February 16, 2021

RE: Response 2 to Peer Review Comments – Site Plan Review  
Thorndike Place Comprehensive Permit Application

On behalf of the Applicant, Arlington Land Realty LLC, BSC Group, Inc. (BSC) is pleased to provide the following responses to peer review for the Thorndike Place residential project on Dorothy Road in Arlington, Massachusetts. This letter responds to comments provided by BETA Group, Inc. (BETA) in a letter to you dated November 20, 2020 as well as comments provided by Mr. Wayne Chouinard, Town Engineer, in a memorandum to you dated December 4, 2020. Please note that this letter is responding to comments from both parties regarding site plan review. Responses to both BETA's and the Town Engineer's comments relating to stormwater management for the project were provided in a separate letter dated January 22, 2021.

THORNDIKE PLACE  
PROPOSED SITE PLAN MODIFICATIONS SKETCH  
FEBRUARY 16, 2021

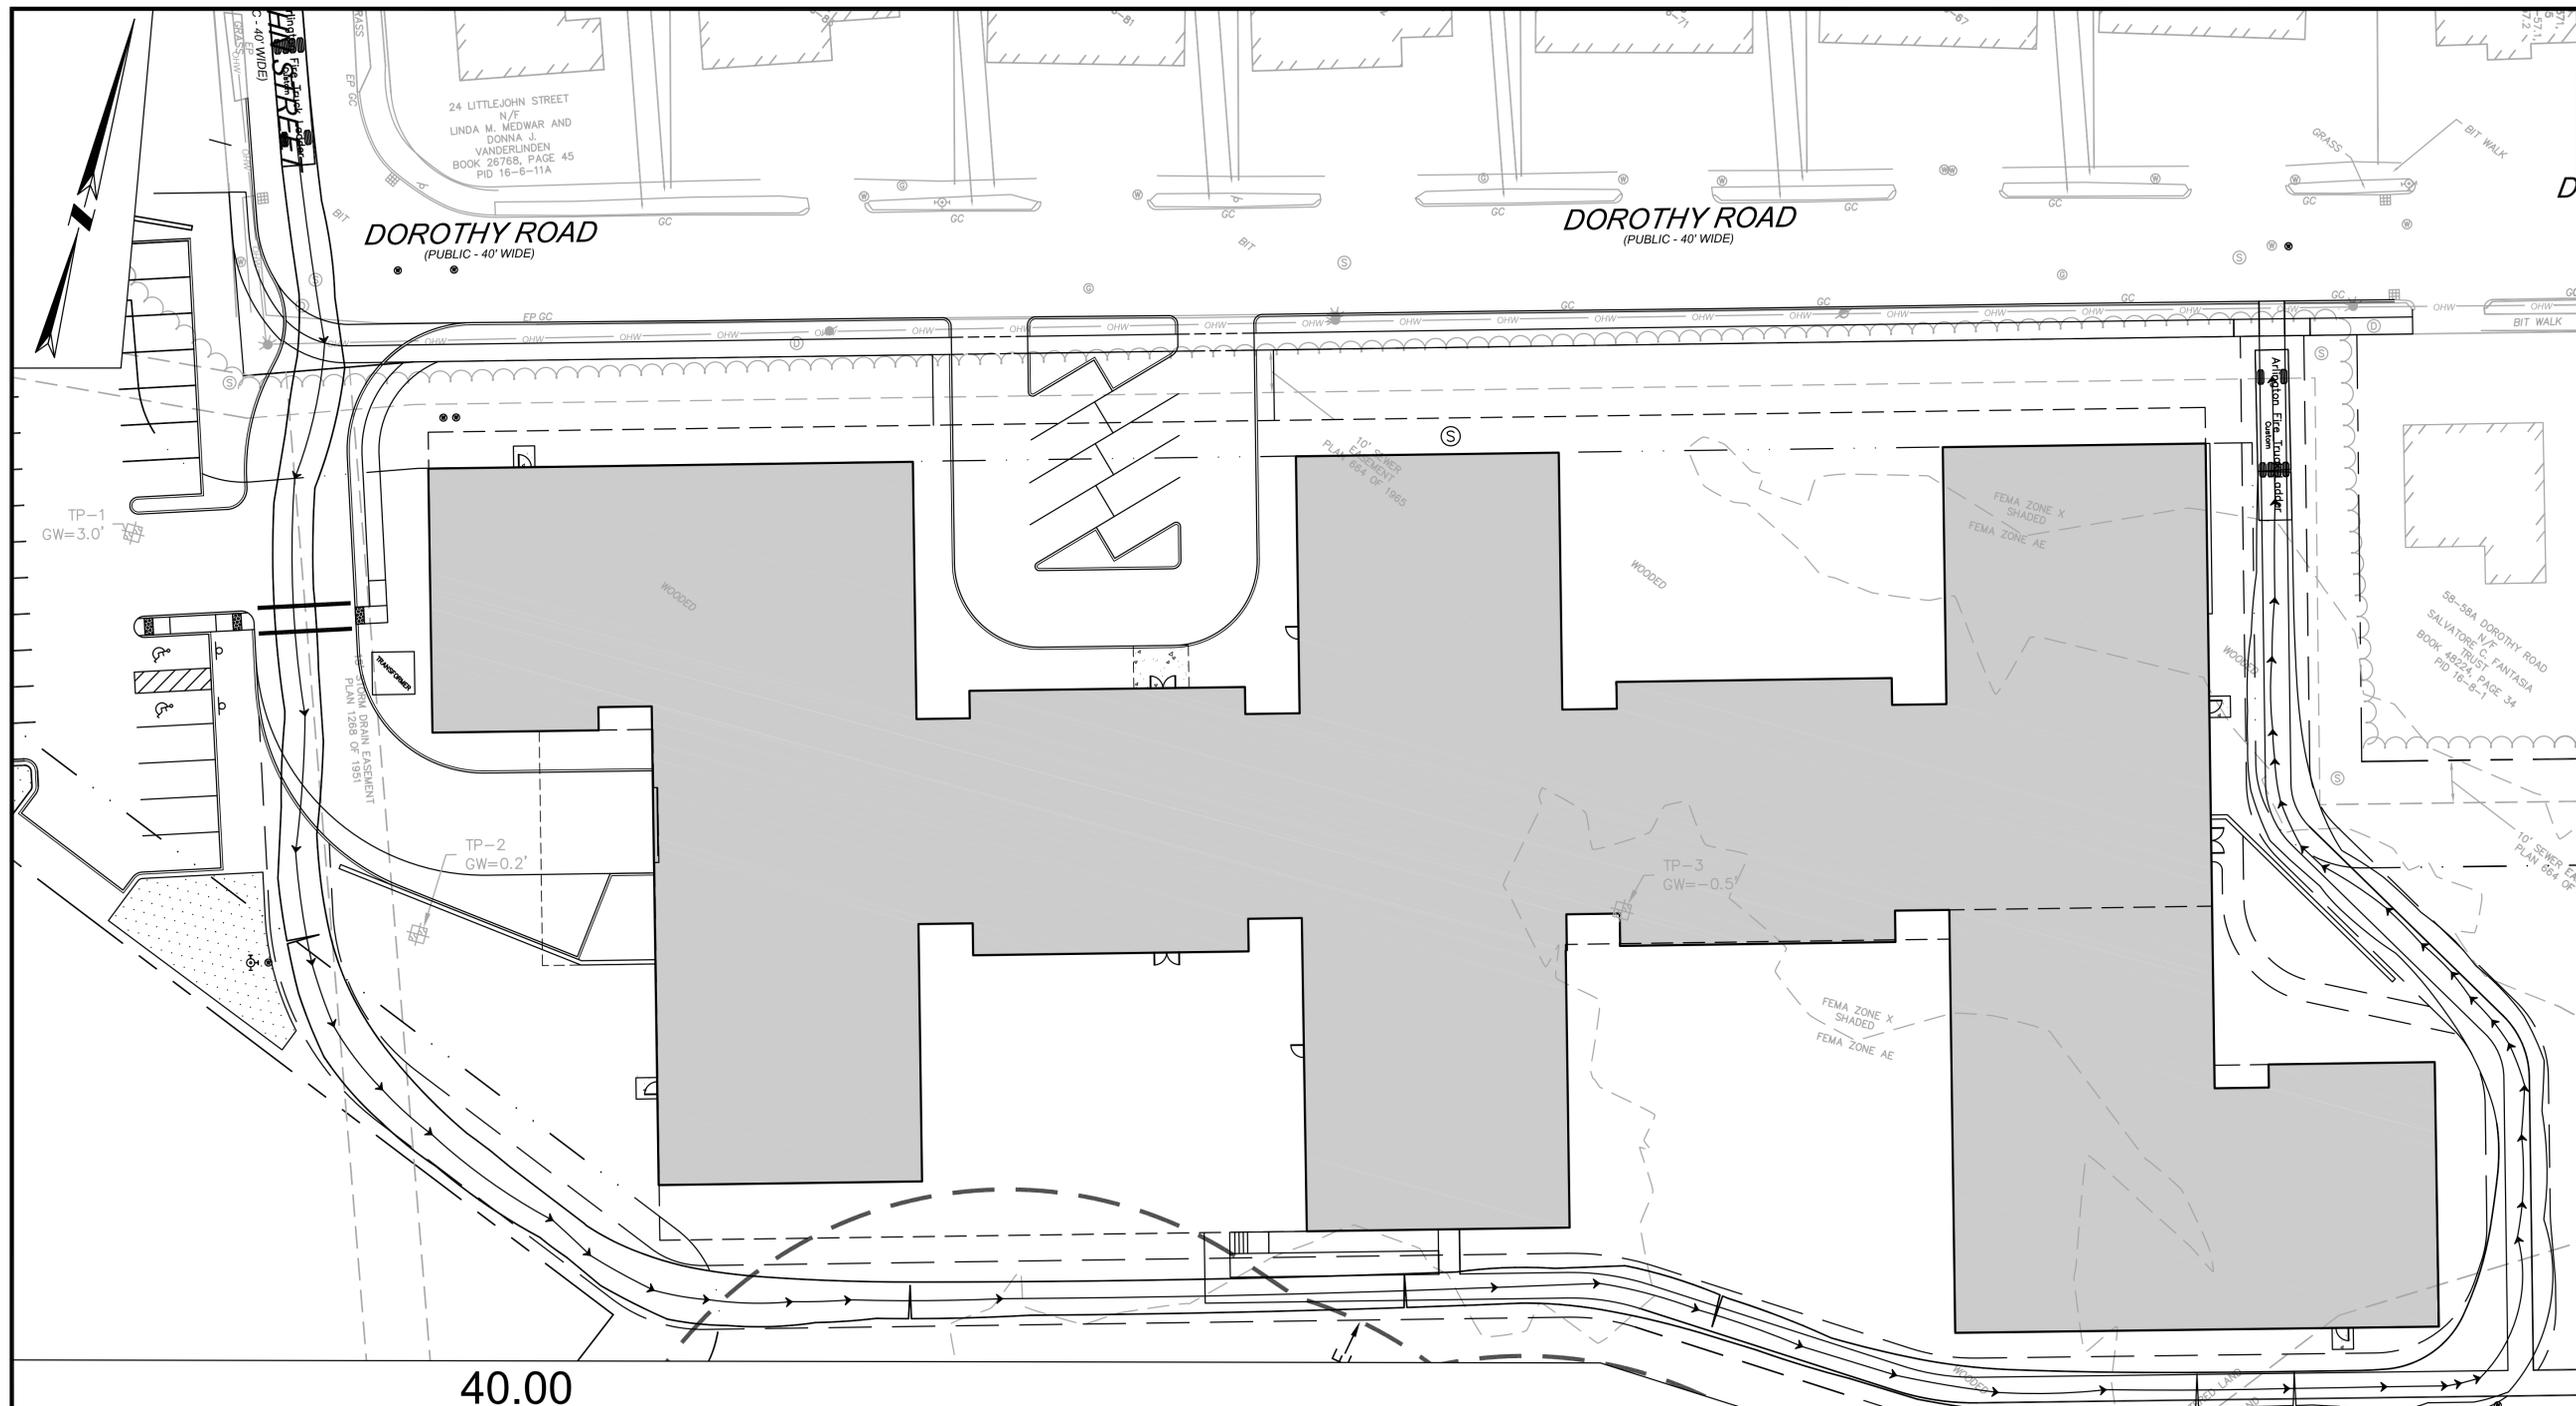
Subsequent to the dates of the BETA letter and Town Engineer memorandum, the ZBA held a public hearing on architecture and urban design on January 26 and a working session on February 4. In response to comments received at those meetings, the Applicant is proposing building, parking and site plan modifications shown on the attached site plan sketch prepared by Oaktree entitled Proposed Site Plan Modifications Sketch, dated February 16, 2021, and as listed below:

- Please clarify the access/egress and parking configuration proposed at the front drop off/pick up entrance of the building including dimensions and turning radius. The parking space orientation does not conform to the expected traffic flow direction.

- Reduction in building height along Dorothy Road
- Reduction to 172 units<sup>1</sup>
- Reduction in parking to a ratio of 1.12 spaces per unit or 193 spaces
  - Parking for four (4) vehicles and one accessible van in the front courtyard
  - 10 parking spaces in the western surface lot
  - The balance of the parking, approximately 178 spaces, would be in the garage
- Relocation of the Children's Play Area to the west side of the building
- Inclusion of an accessible pedestrian connection from the southwest courtyard to the relocated Children's Play Area and surface parking
- Inclusion of a potential Bluebikes station adjacent to the surface parking area

*Response: The proposed courtyard circulation will be reversed to provide counter clockwise circulation. Dimensions and traffic flow directions will be shown on the final site plans submitted for review for consistency with the Board's decision.*

### TRUCK TURNING FIRE TRUCK ACCESS

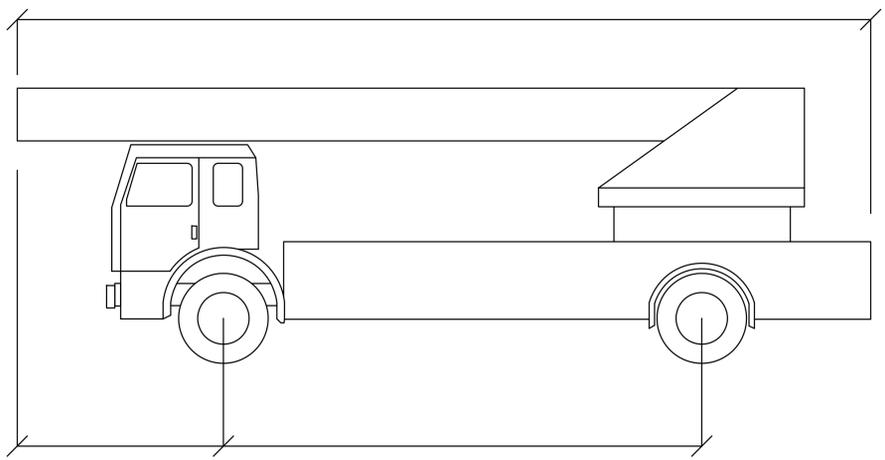
2. A 15-ft wide pervious paver emergency access drive is shown looping around the rear of the main site building.

**Recommendation: The Applicant should confirm that the access drive can accommodate an emergency vehicle (fire truck) turning around the southeast corner of the site building.**

*Response: A truck turning exhibit has been prepared showing the emergency vehicle route, a copy of which is enclosed herein. The turning radius specifications were provided by the Arlington Fire Department.*

COMPENSATORY  
FLOOD STORAGE

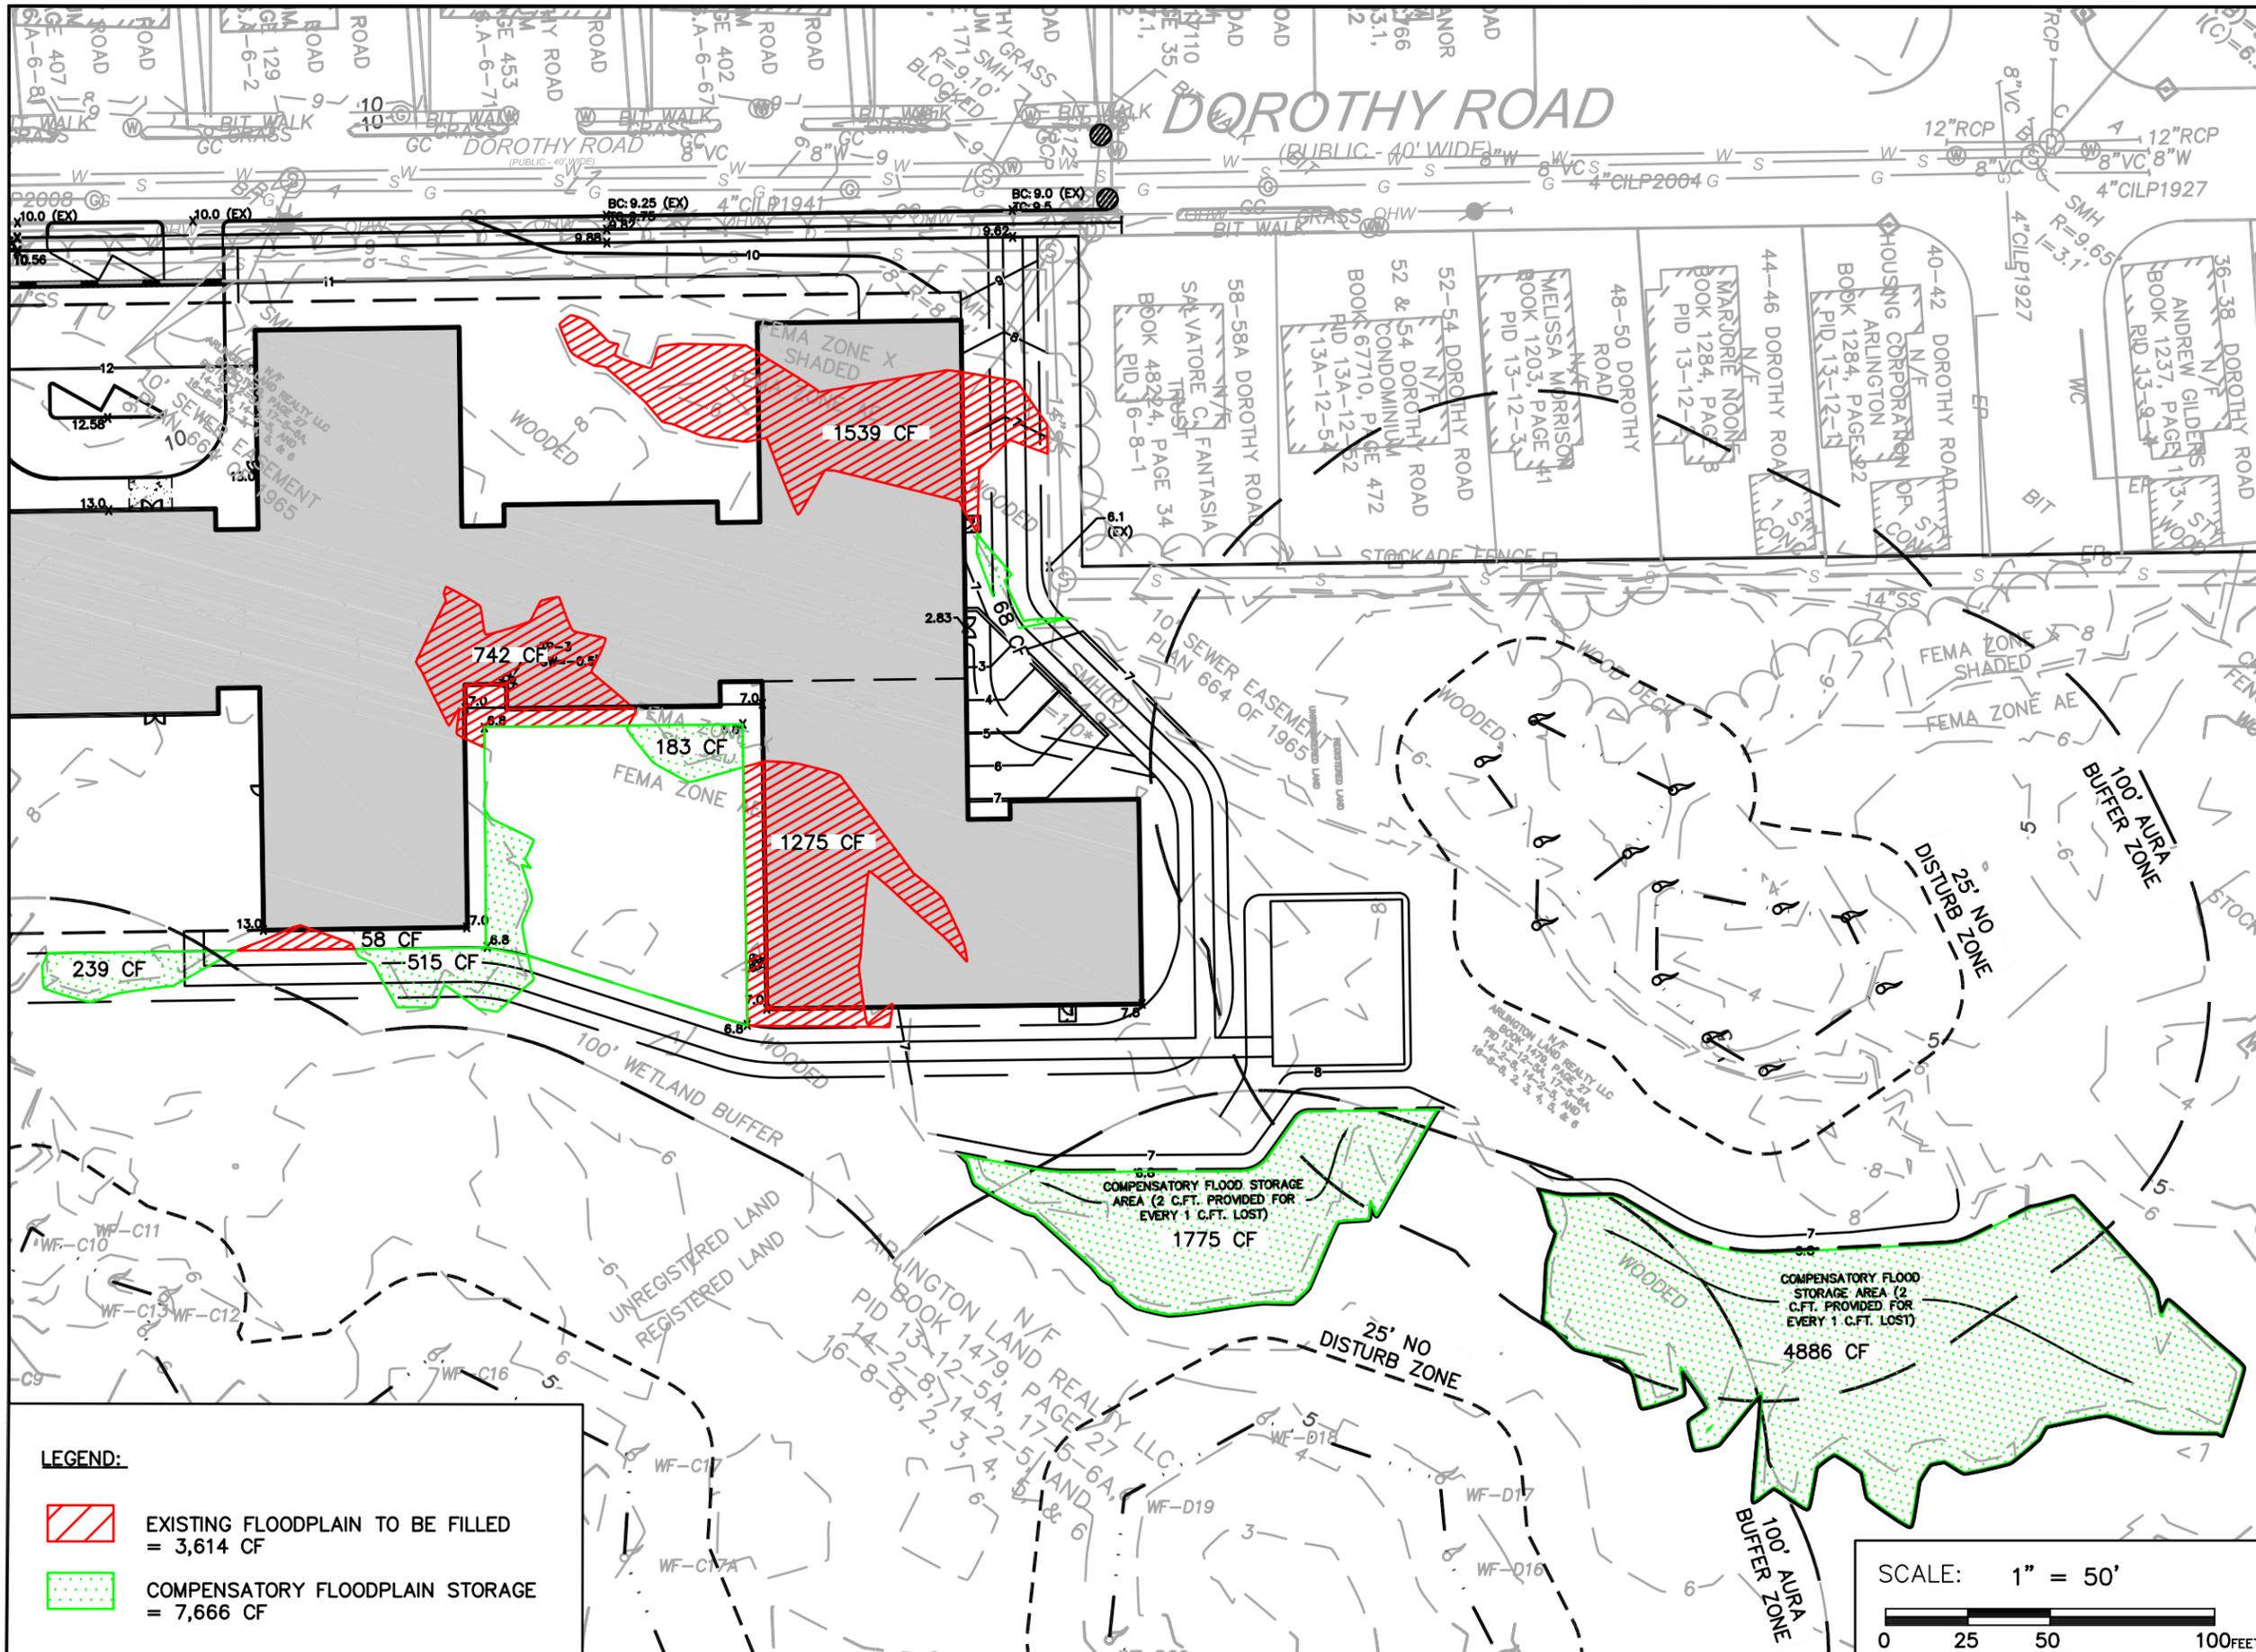
13. A portion of the proposed project design requires filling within the 100-year flood plain. Compensatory storage is required on a 1:1 (per foot) basis by the Mass Wetlands Protection Act (310 CMR 10.57) and on a 2:1 basis by the Arlington Wetlands Bylaw.

The applicant has provided compensatory flood plain storage calculations in the stormwater report (Sec. 2.12) and has designated an upland area on the site plan southeast of the proposed building for compensatory storage. In addition, the southeast courtyard area is labeled "Open Space / Flood Storage".

**Recommendation: The Applicant should provide a plan graphic showing the existing flood plain area being altered by the proposed building / site development, currently the building hatch is obscuring the flood plain limits. The proposed compensatory flood storage volume calculations and designated flood storage volume area appear consistent.**

*Response: A floodplain impacts and compensatory storage exhibit was previously submitted. A revised floodplain impacts and compensatory storage exhibit considering the Isolated Vegetated Wetlands (IVW) and AURA is attached. The proposed compensatory storage areas located within the AURA to BVW or IVW have been located, where possible, within the outer 50 feet of the AURA. This work is also considered a temporary disturbance area and once the compensatory storage work is complete, it will return to its natural function as AURA and Land Subject to Flooding.*
